ADC Telecommunications				1		7280		5/12/93		DWB			
								REV		ECO		DATE		APV			
APV		THIS PRINT IS THE PROPERTY OF ADC, IT SHALL NOT BE COPIED WITHOUT PERMISSION.				TITLE SCH, VHF FILTER/ AMPLIFIER BD. HIGH O/P (1198-1606)											
DATE		MATERIAL -----				DWN		SJM		3/8/93		DWG. NO.				REV	
ECO		FINISH -----				CHK		DWB		3/25/93		1198-3606				3	
REV						REL		DWB		3/25/93		C		SCALE ---		SHEET 1 OF 1

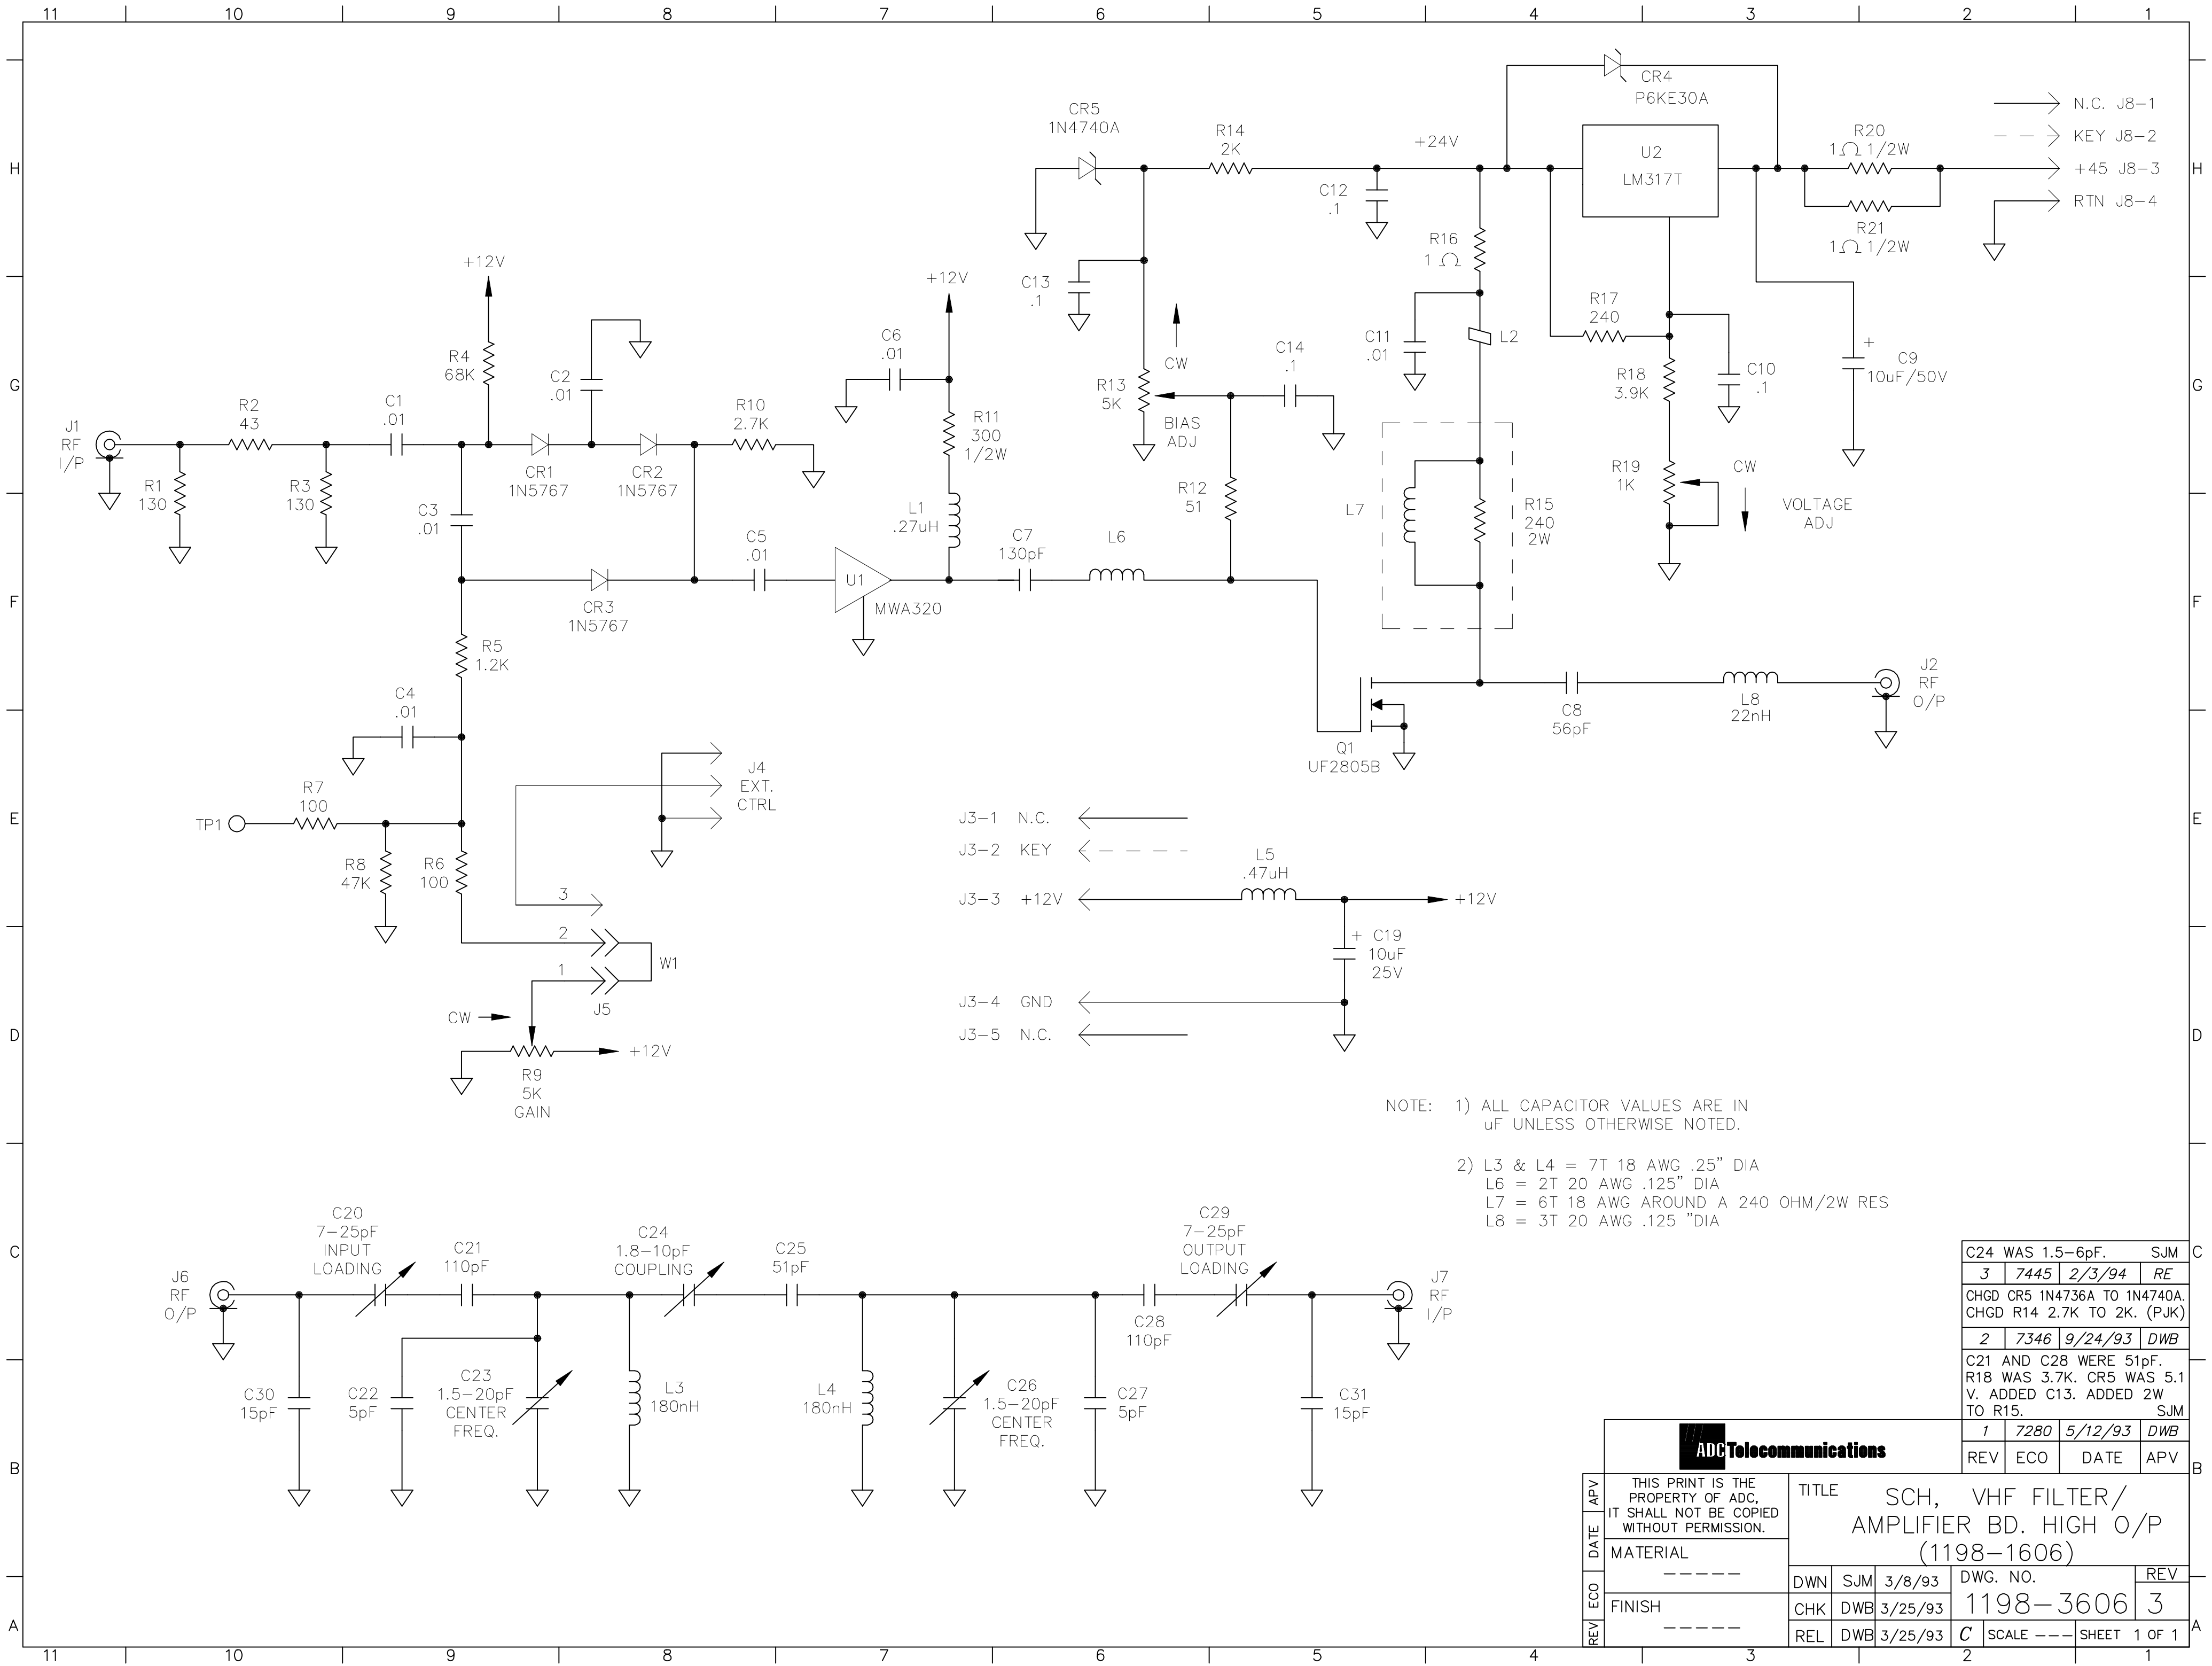
C24 WAS 1.5-6pF. SJM			
3	7445	2/3/94	RE
CHGD CR5 1N4736A TO 1N4740A. CHGD R14 2.7K TO 2K. (PJK)			
2	7346	9/24/93	DWB
C21 AND C28 WERE 51pF. R18 WAS 3.7K. CR5 WAS 5.1 V. ADDED C13. ADDED 2W TO R15. SJM
